TOWN OF NISKAYUNA
Planning Board and Zoning Commission
Agenda
April 25, 2022
7:00 PM

TOWN OF NISKAYUNA

AGENDA STATEMENT

ITEM TITLE: DISCUSSION: 2341 Nott St. – St. James Plaza – site plan application for placement of a Chase Bank ATM in a portion of the Shop Rite parking lot.

A102

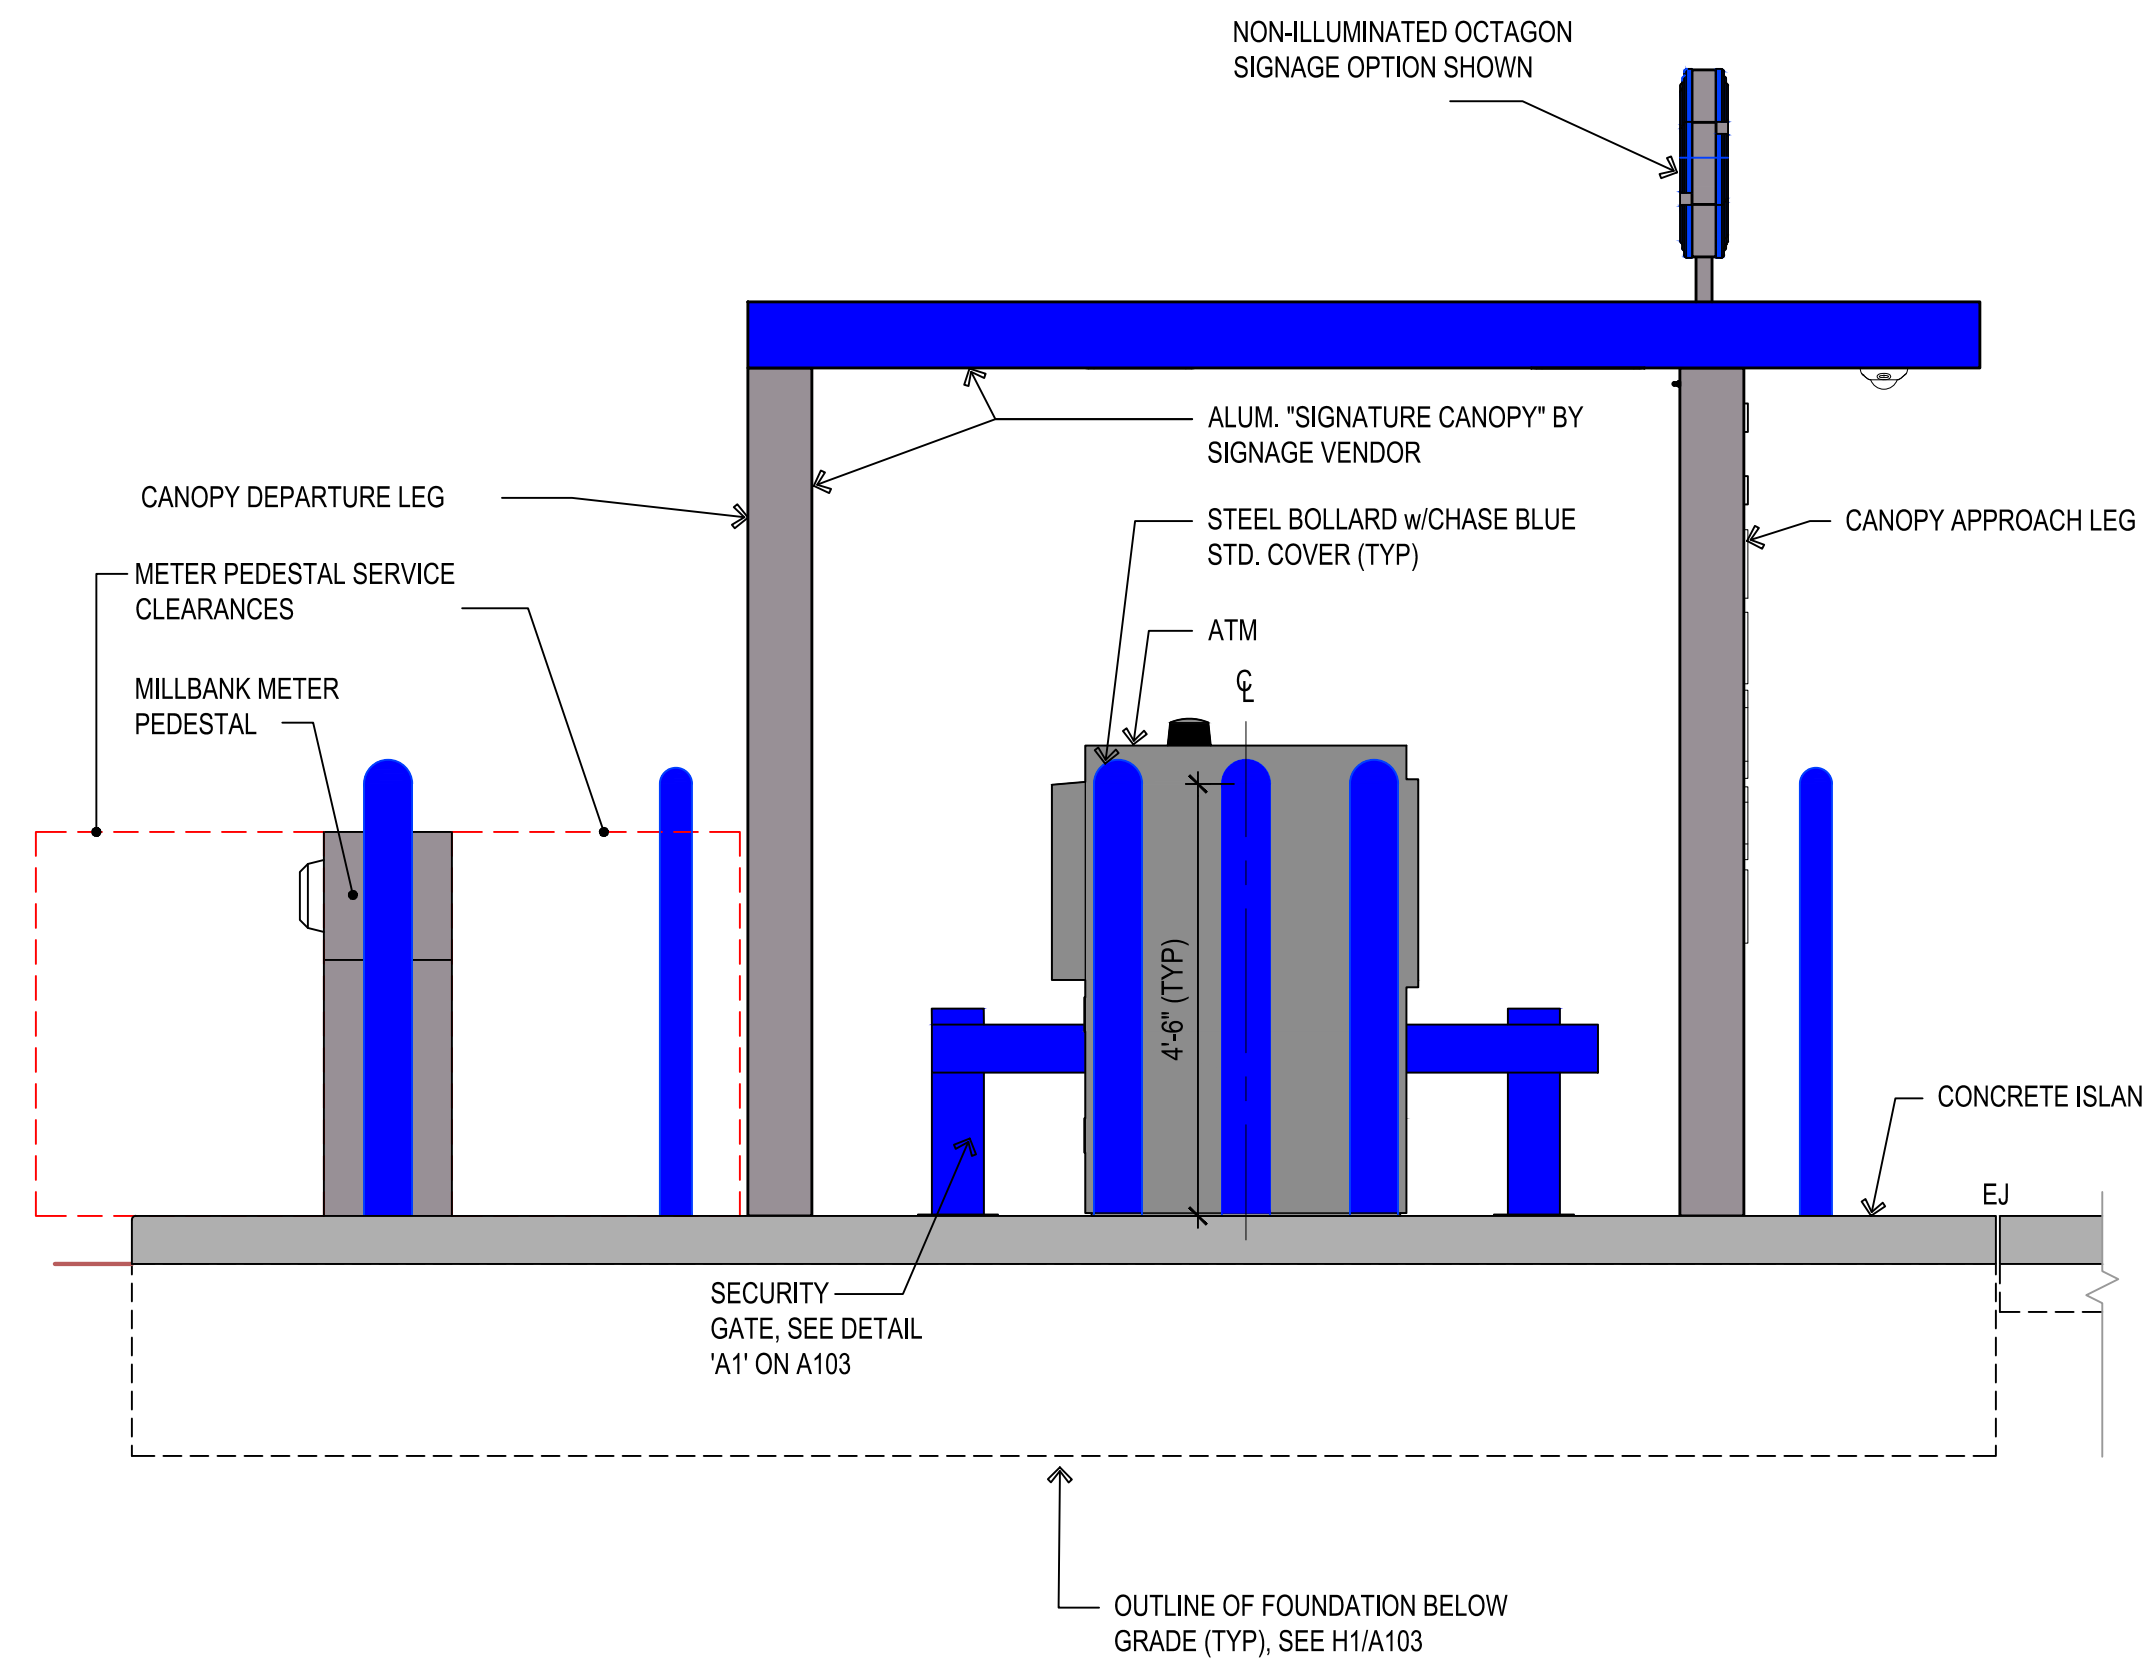
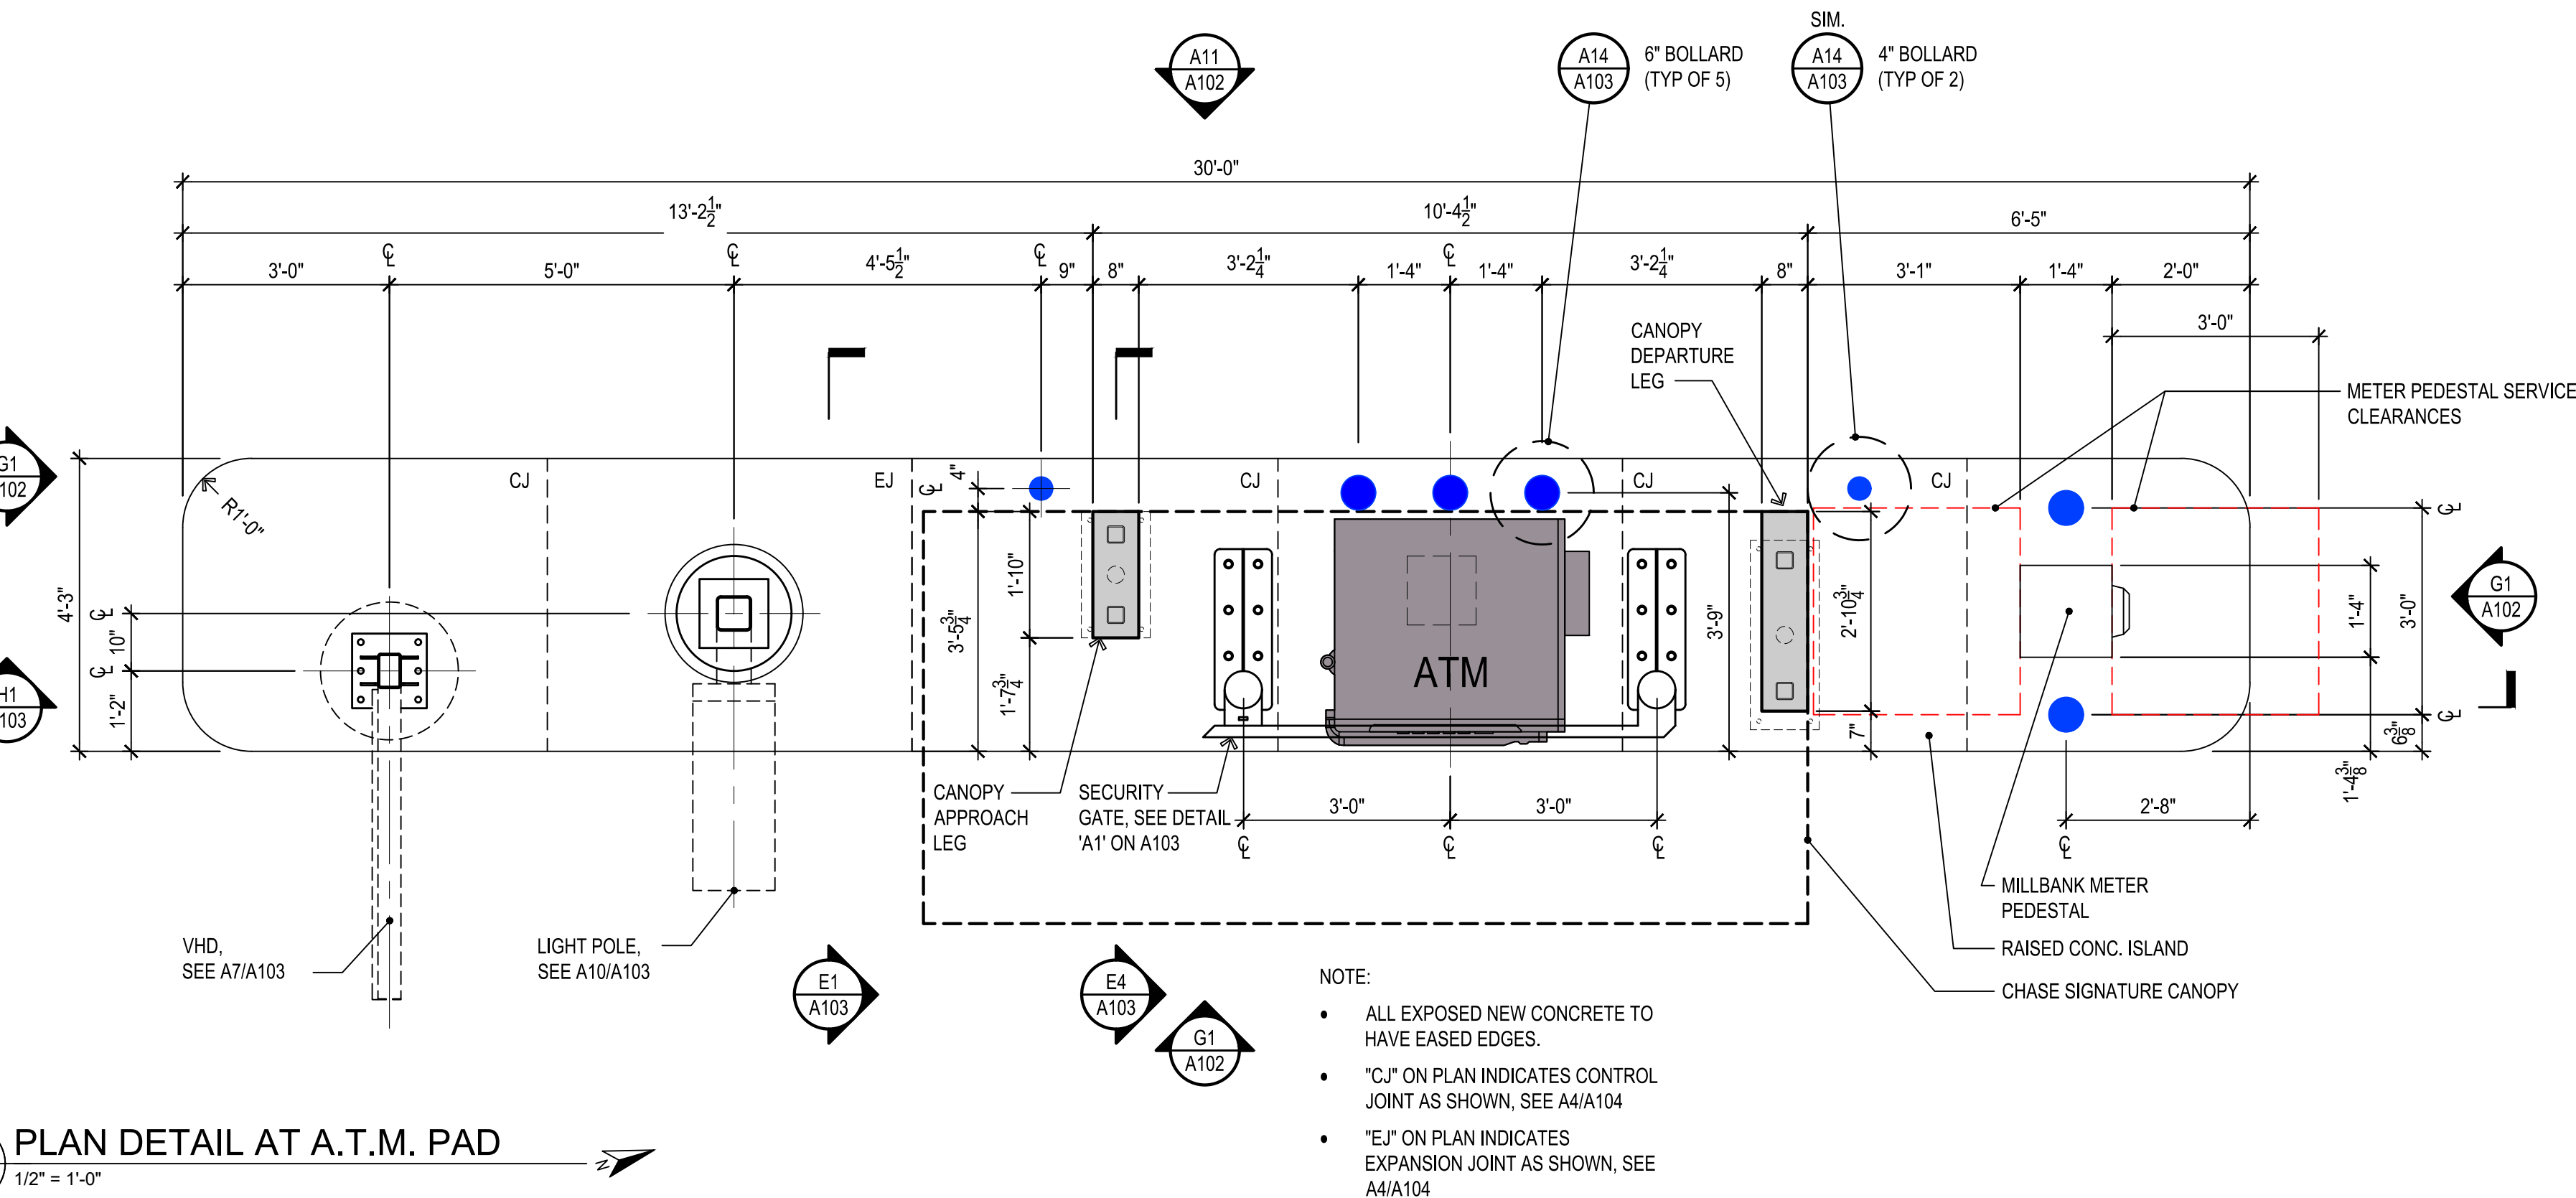
As proposed, page A102 of the drawing set includes a light pole with an area light measuring 23' high (3' high concrete base + 20' high light pole) located at the entrance to the ATM machine. Therefore, a waiver of 1' (23 – 22) of pole height from finished grade is required.

Pages A102, A103 and A104 of the aforementioned drawing set include design details for the proposed ATM. Several portions of the ATM station infrastructure and associated graphical displays should be reviewed by the Board relative to the requirements set forth in Section 220-4 of the zoning code. The drawings include a "non-illuminated signage option" that reads "CHASE" followed by the Chase Bank logo on one of the canopy legs.

E10
A104
DOT SIGN DETAIL - POLE MOUNTED
NTS

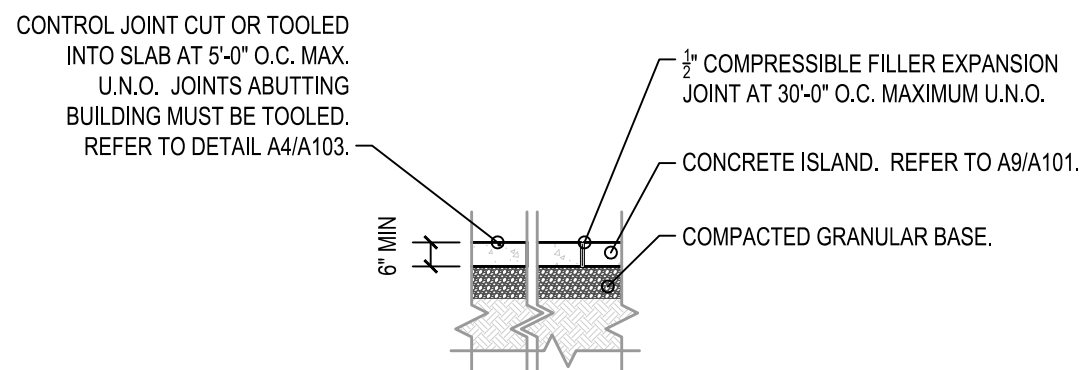
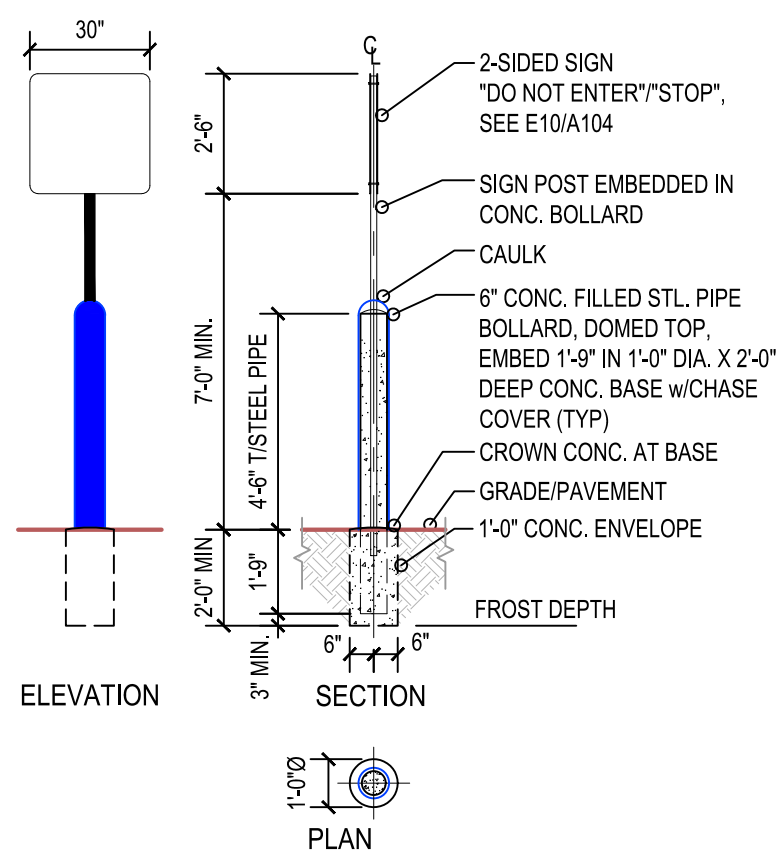
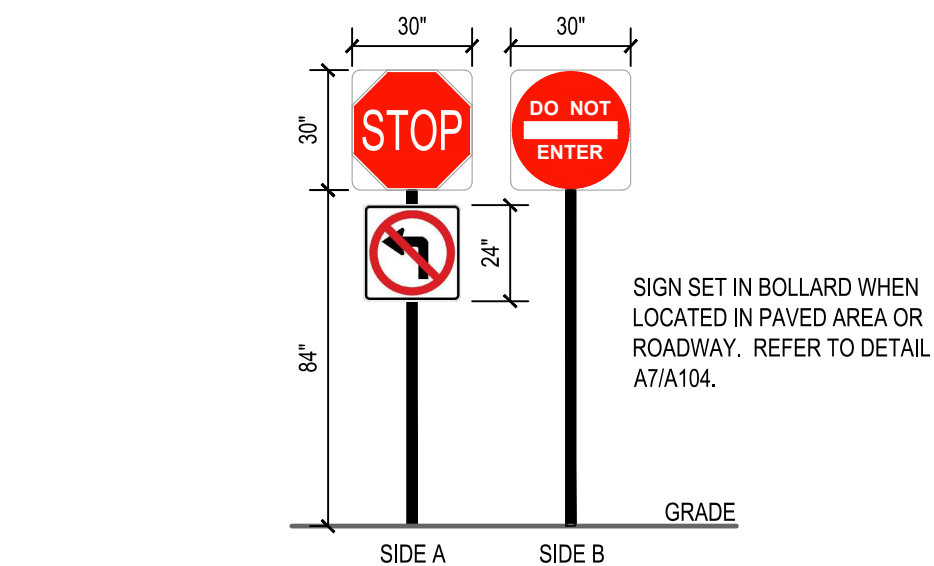
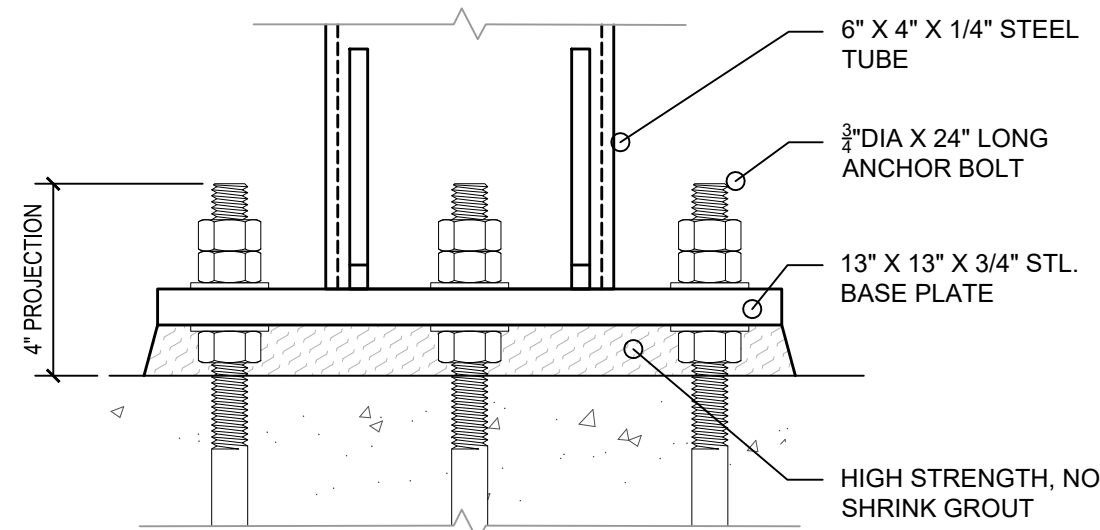
As proposed, page A104 of the drawing set includes a lighting fixture described as "Model ALED2T150N (Type II) 4000K LED 120-277V 151.4 Watts LED area light". Therefore, a waiver for an LED light rather than a metal halide light is required.
